**PUBLIC HEARING – ZONING CASE 2024-023**  
**PETITIONER: SHAHID RASUL**

**RE: Zoning Case 2024-023 & PSP 2024-036 – Split Trail Townhomes – Appeal Request**

## AGENDA ITEM NO. 4A

**DESCRIPTION:** Request to rezone **from** Corridor Commercial **to** Single-Family Residence Attached on 6.6 acres located on the west side of K Avenue, 2,240 feet south of Spring Creek Parkway. Project #ZC2024-023.

**ZONING EXHIBIT**

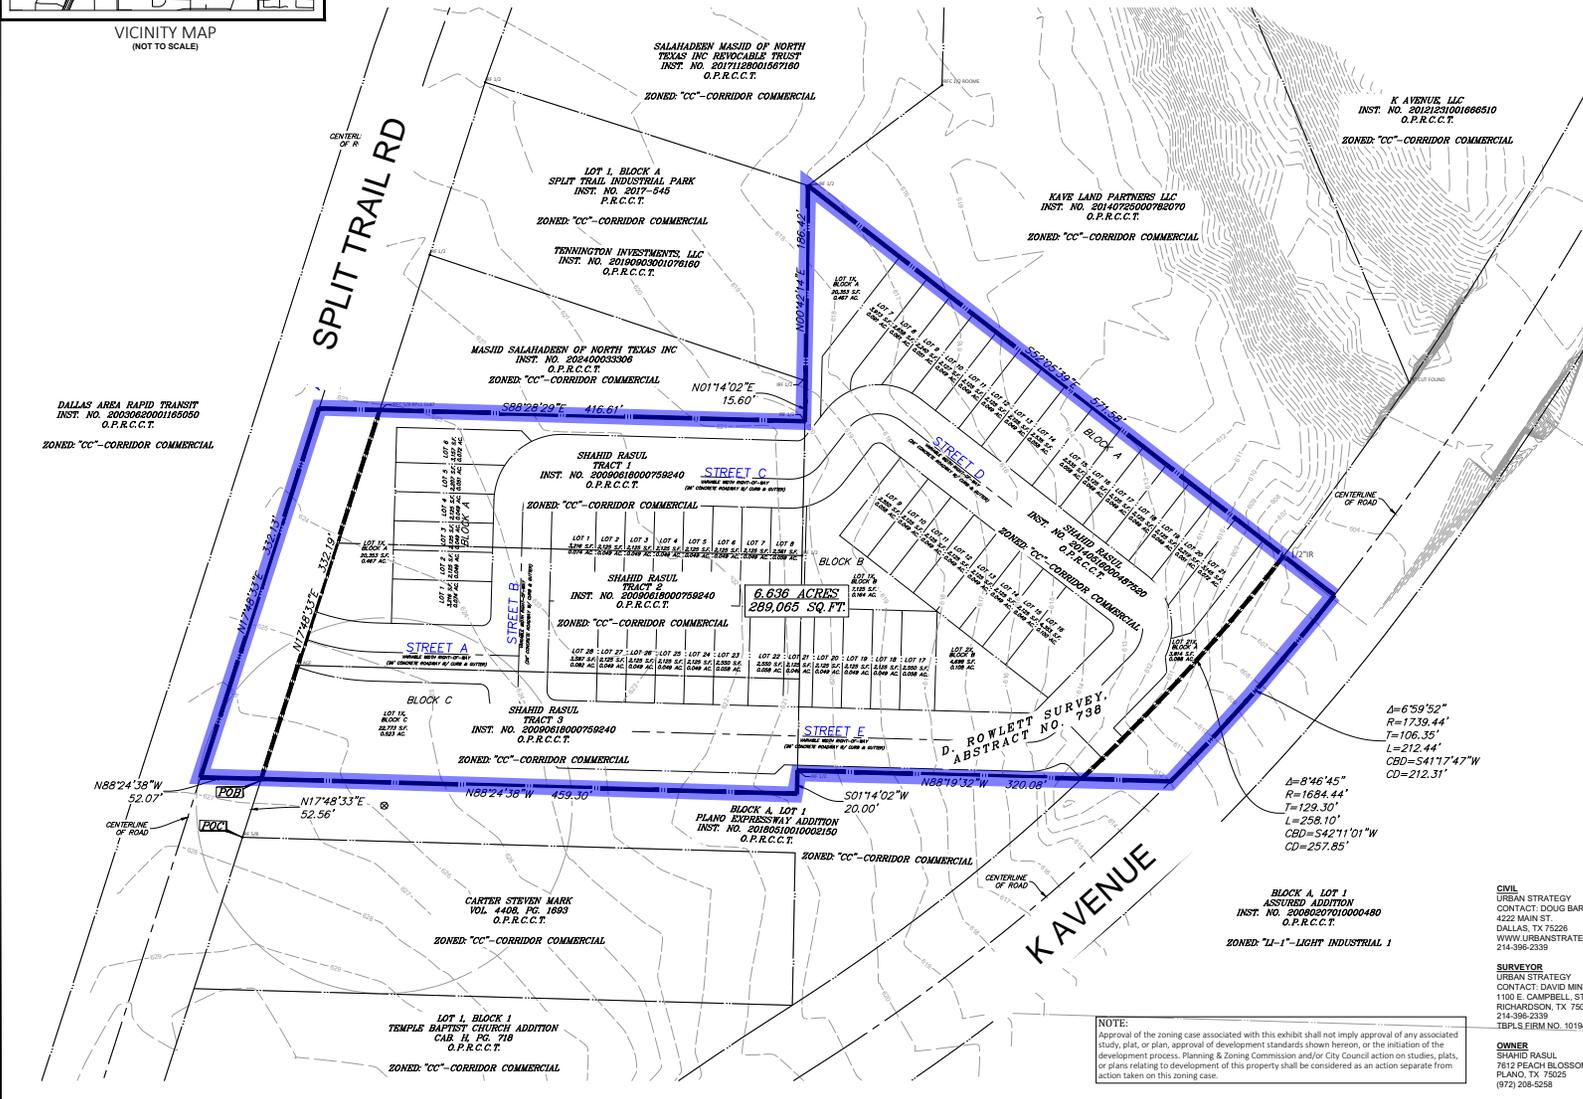
- Compatibility with Surrounding Area – The subject property is located within a commercially zoned corridor that is developed with a mix of retail, heavy commercial, and light industrial uses, including a business that produces compost, mulch, and other landscaping materials that are known to create strong odors, deposit debris in the surrounding area, and are at elevated risk for fires due to the nature of the work on site. A residential subdivision in this location would be isolated from other residential services, such as elementary schools and neighborhood parks, by DART right-of-way and K Avenue. For these reasons, the request is incompatible with the surrounding area.

- Impacts to Adjacent Properties – Rezoning the property to residential will create additional restrictions on the development of adjacent properties, including requirements to construct 8-foot masonry screening walls and residential adjacency standards. It would also cause the commercial antenna located on the property to the south to become nonconforming with setbacks from residential zoning districts.

- Access – Two points of access to the neighborhood are proposed, including one from Split Trail Road and one from K Avenue. The property can only get direct access from the existing median opening on K Avenue by sharing a driveway with the commercially-zoned property to the north. (Note: the subdivision of these properties was done without the benefit of a plat by a previous owner). Shared access is a typical condition between commercial properties but is not typical between commercial and residential property outside of a mixed-use area.

The applicant did not attempt to coordinate with the adjacent property owner on this issue and, as a result, is proposing access from K Avenue farther to the south. This will require residents traveling northbound on K Avenue to perform a U-turn to access the neighborhood from southbound K Avenue. Alternatively, residents could turn left onto Split Trail Drive where it intersects K Avenue approximately one-quarter mile south. This design requires approval of a variance to the Street Design Standards and creates unnecessary traffic safety risks that would likely be avoided if the site were developed with non-residential uses under its existing CC zoning.

- Expressway Corridor Environmental Health Map – The location is within EHA-1. An EHA Site Analysis was provided as part of the request, which found the proposed development is not consistent with the EHA guidelines. The applicant is proposing mitigation standards for air filtration, to limit indoor noise levels, restrict balconies facing the expressway, and construct solid fencing to buffer the affected buildings; however, as this request is not for a Planned Development, these mitigation measures cannot be stipulated as part of the zoning (i.e., required of the development). Therefore, the request does not conform with EHA guidelines.

**PRELIMINARY SITE PLAN:** Split Trail Townhomes, Block A, Lots 1-21, 1X & 2X, Block B, Lots 1-28, and Block C, Lot 1X

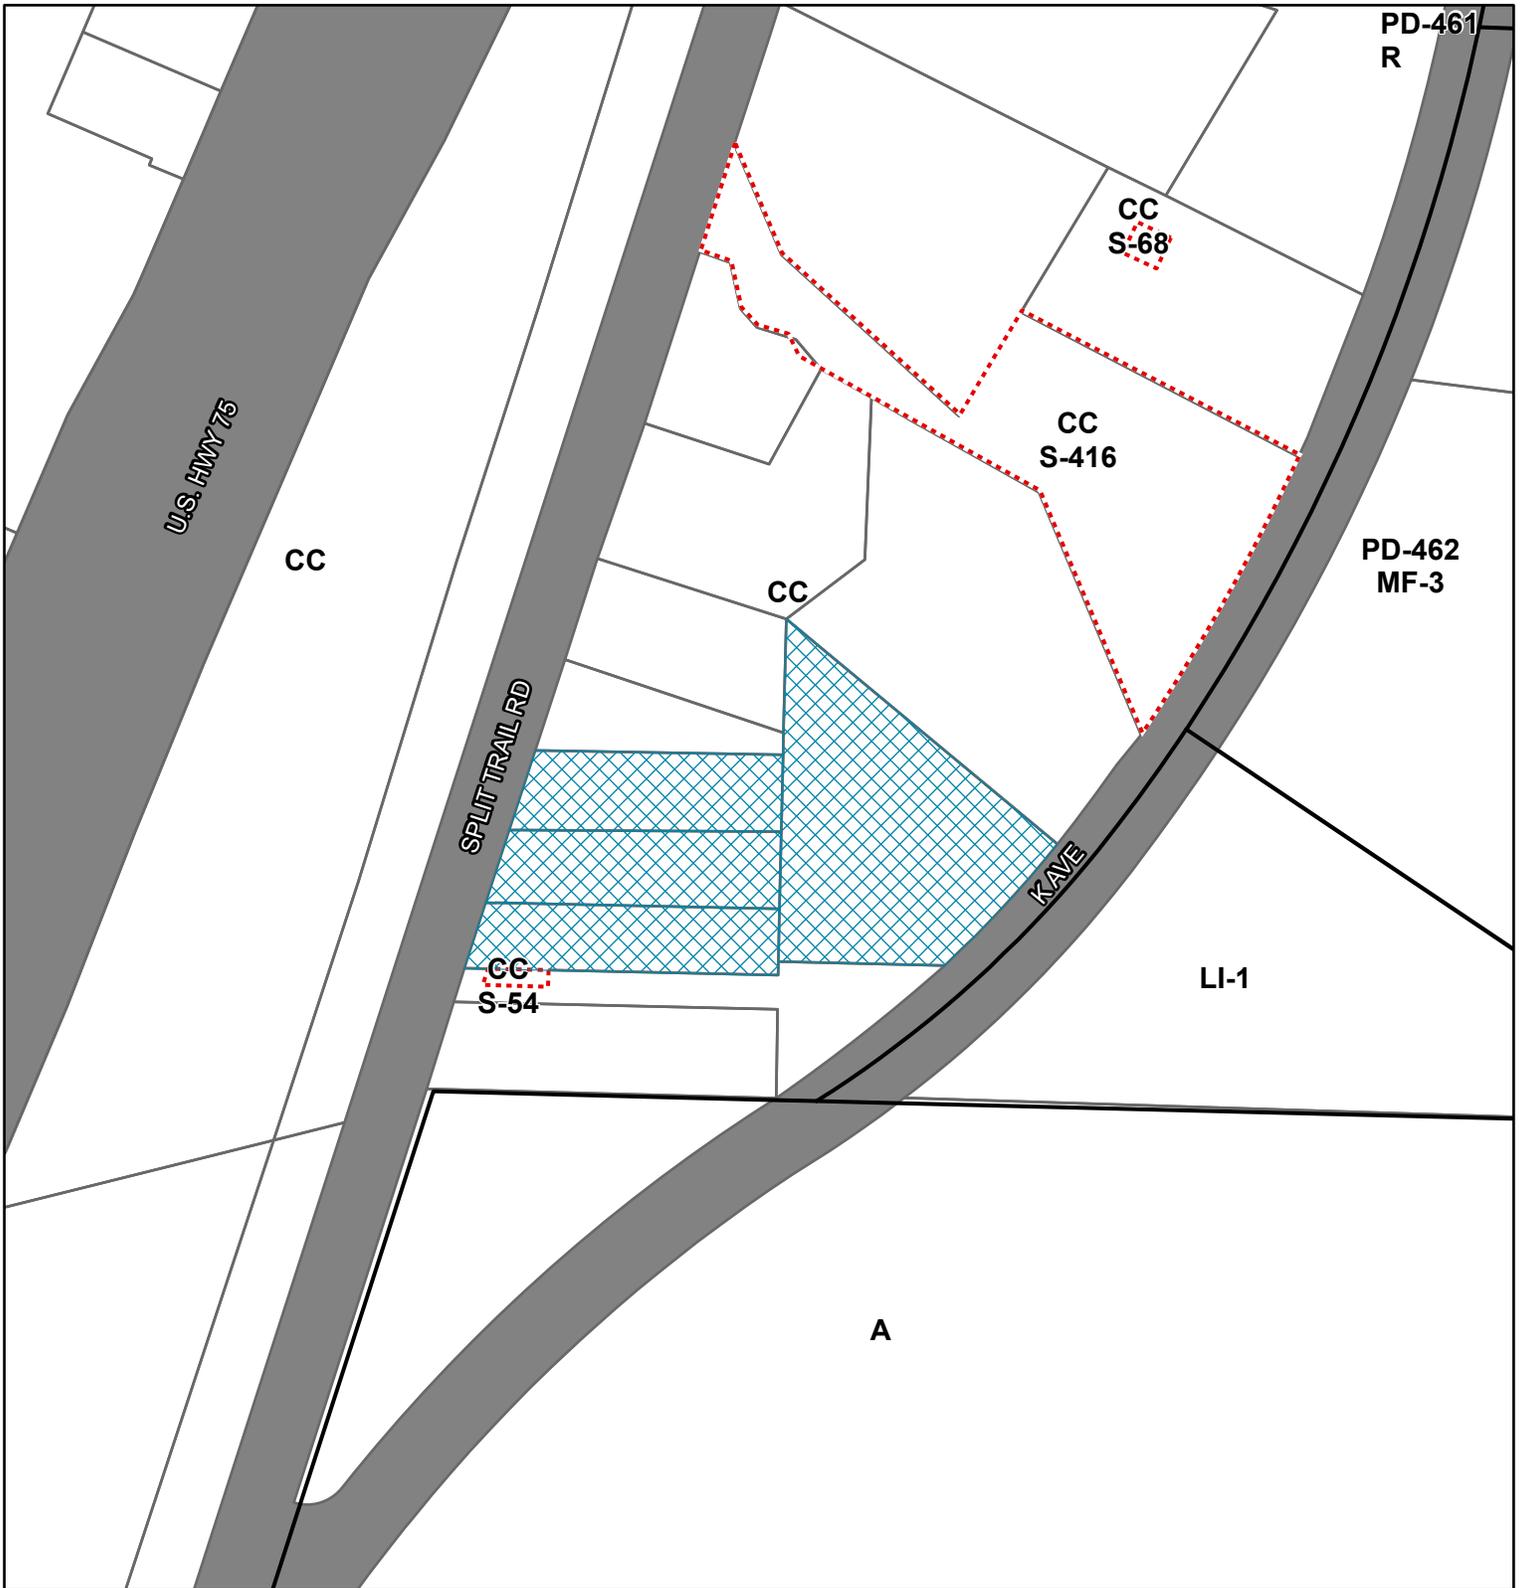
This Preliminary Site Plan is associated with Zoning Case 2024-023 and is contingent upon approval of the zoning case. The purpose for the Preliminary Site Plan is to show the proposed Single-Family Residence Attached development and its associated improvements.

The preliminary site plan proposes a driveway located approximately 140 feet south from the existing median opening. The required driveway spacing along this portion of K Avenue is 235 feet and will require approval of a variance to the Street Design Standards from the Engineering Department. If the variance is denied, a revision to the preliminary site plan will be required.

If approved by the Commission, staff recommends the approval be subject to:

1. City Council approval of Zoning Case 2024-023; and
2. Approval of a variance to the Street Design Standards by the Engineering Department for driveway separation from a median opening.
